RTI 25-26-62
the following information has been released in response to a request for information relating to Mudwalls Road

MIDLAND HIGHWAY

BACKGROUND, UPGRADES & CRASH PERFORMANCE

From: Out of Scope
Sent: Thursday, 3 April 2025 12:02 PM
To: Out of Scope
Subject: RE: Midland / Mud Walls

Mud Walls Road

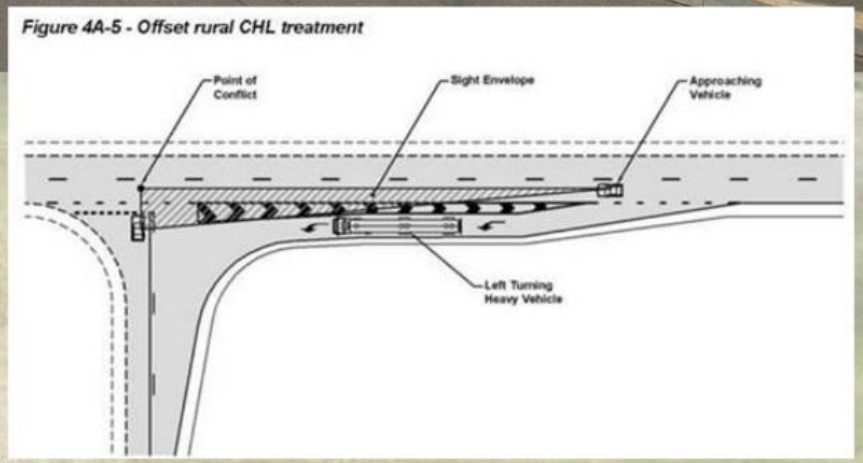
9 Crashes post upgrade

0 Fatal
1 Serious
3 Minor
1 First Aid
4 PDO

52112663 – 2/9/2023 –Vehicle southbound in Midland tried to exit onto Mud walls, going too fast & slid off road – PDO
52288721 – 16/2/2024 – Vehicle turning right from Mudwalls failed to give way to vehicle travelling south on Hwy – Minor
52612743 – 23/12/2024 – Vehicle turning right from Mudwalls failed to give way to vehicle travelling south on Hwy – Serious
52646326 – 26/1/2025 – Vehicle turning right from Mudwalls failed to give way to vehicle travelling south on Hwy – Minor
52709306 – 23/3/2025 – Vehicle turning right from Mudwalls failed to give way to vehicle travelling south on Hwy – PDO
52709274 – 27/3/2025 – Vehicle turning right from Mudwalls failed to give way to vehicle travelling south on Hwy – PDO

Figure 4A-5 - Offset rural CHL treatment

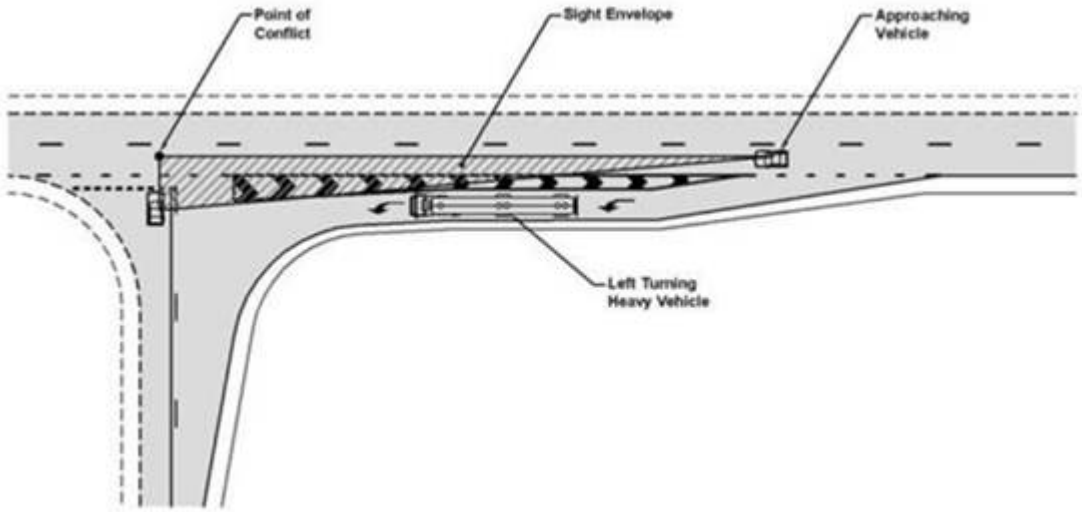
Motorists turning out of Mud Walls Road have good sight distance to the right, towards southbound traffic.

I wonder if their sight distance to southbound traffic is sometimes being obscured by vehicles in the left turn deceleration lane.

This type of problem was previously experienced at the Bass Highway / Gilbert Street junction at Latrobe where the construction of a left turn deceleration lane led to a dramatic increase in the number of 'right near' type crashes where a vehicle turning right out of the side road was hit by a vehicle approaching from the right.

Queensland Main Roads produces supplements to the Austroads Guides. One of their publications – Road Planning and Design Manual – Edition 2, Volume 3 provides the following advice.

Significant numbers of vehicles, particularly heavy vehicles making a left turn from the major road at an intersection with an AUL/AUL(s)/CHL/CHL(s), may restrict the sight distance for vehicles turning out of the minor road, particularly right turning vehicles.

In this situation, offsetting the left turn lane from the adjacent through lane on the minor road improves the sight distance for vehicles turning out of the minor road. In particular sight distance to vehicles following a left turning vehicle can be substantially improved. An offset left turn lane should therefore be considered at an intersection where sight distance past left turning vehicles may improve the intersection safety.

This type of treatment, with a chevron providing separation between the left-turn deceleration lane and the adjacent through lane, was retro-fitted at the Bass Highway / Gilbert Street junction and there have been no further crashes since its implementation.

A similar treatment might offer a solution to some of the problems being experienced at the Midland Highway / Mud Walls Road junction.
